NUCLEAR REGULATORY COMMISSION

Title: Advisory Committee on Reactor Safeguards
EPR Subcommittee

Date: Friday, May 21, 2010

The purpose of this meeting is to continue our review of the SER with Open Items for the combined for the Combined License Application submitted by UniStar Energy for the Calvert Cliffs Nuclear Power Plant Unit 3.

Loss of Offsite Power

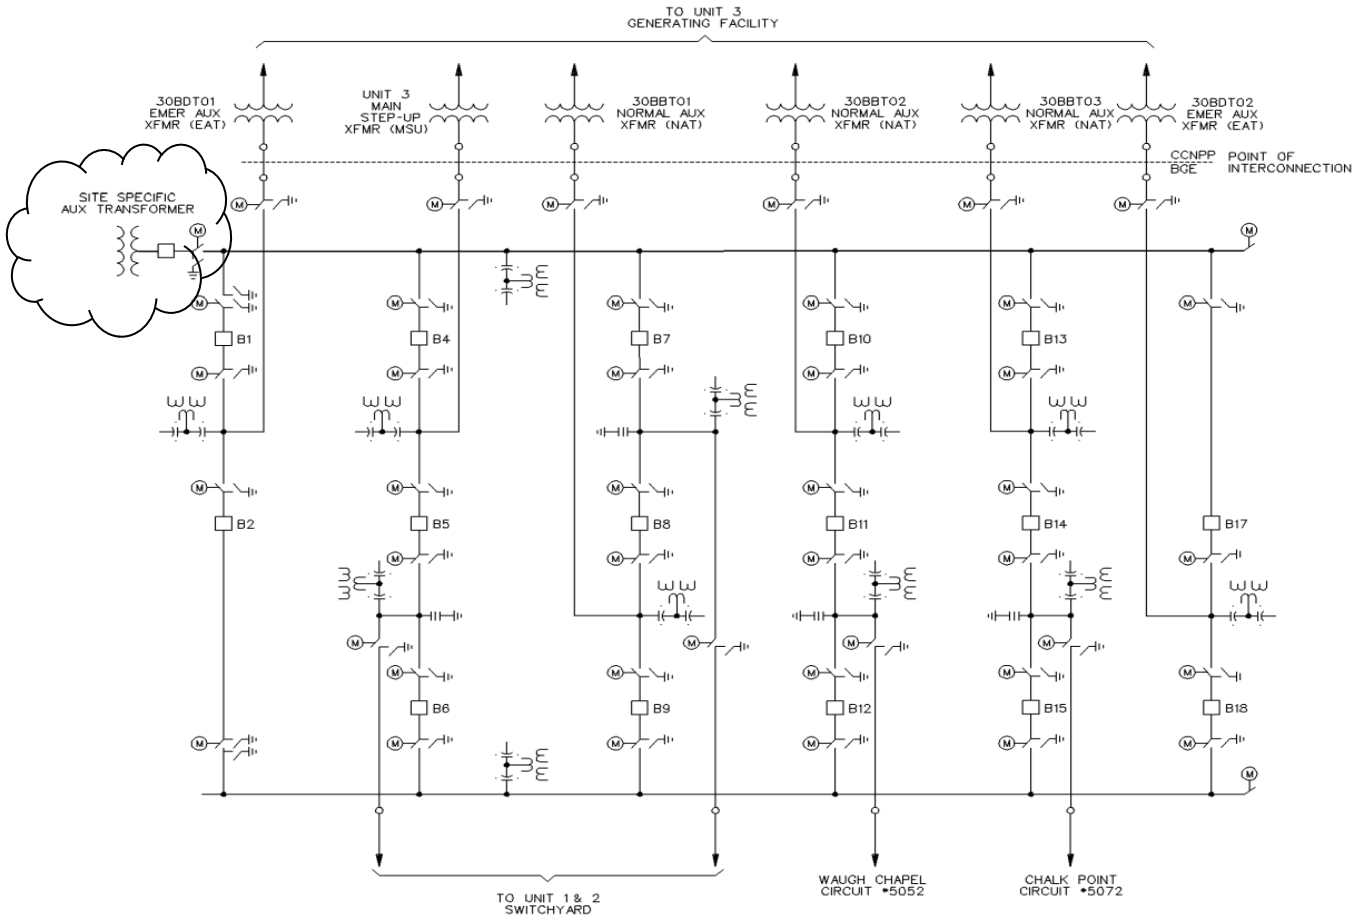
reconfigured the 6.9 kV and 480 volt electric power configuration, to some extent. You've added some 480 volt motor control centers in the ultimate heat sink makeup water building, that didn't exist in the certified design.

You've reconfigured some of the baseloads on a 6.9 kV system. You've added a new supply to support the switchyard loads, out in the switchyard, which could affect offsite power recovery probability some.

I'm curious why the electric power system model in the PRA doesn't need to be revised to account for those changes.

The US EPR FSAR has a conceptual switchyard design and the breaker-and-a-half scheme -- and this gets at the question that you asked, Dr. Stetkar, or it will open the opportunity to continue the dialogue.

Restoration of power can rely on one of two breakers. Each breaker has one coil in each and we recognize that this was a question asked earlier and so you can restore by going in either of two directions, which gives you access to two coils, one in each of two different breakers.

The batteries are in two divisions. They are monitored. The detailed design of the batteries in that part of the switchyard is not available, so the short answer is there is not a detailed PRA analysis of the switchyard. There's a review of the features. There's consistency between the Design Certification or US EPR PRA and the switchyard as it's described for the plant and based on that, we have concluded that it is in fact representative of and bounded by the US EPR PRA.

The FSAR has a conceptual switchyard design, it uses a breaker-and-a-half scheme that's been adopted in the COLA so there's no change from that approach and from that general design.

The capability for runback and supply of house loads from the main generator, the Island Mode, is adopted by the Calvert Cliffs Unit 3 plant and is incorporated in the PRA so the treatment is consistent.

There is a site-specific transformer added to support plume abatement, wastewater treatment, desalination and we believe the impact of that is

The key features of the switchyard. The switchyard is incorporated based upon a qualitative evaluation. There is a very detailed FMEA in the FSAR for it and it's been reviewed in great detail.

Any single component can be out of service and it doesn't disrupt connections. The capability for runback and supply, called the Island Mode, is representative of a feature that can prevent reactor trip in cases and thereby reduce the challenges for the nuclear plant to go through a response and shut down.
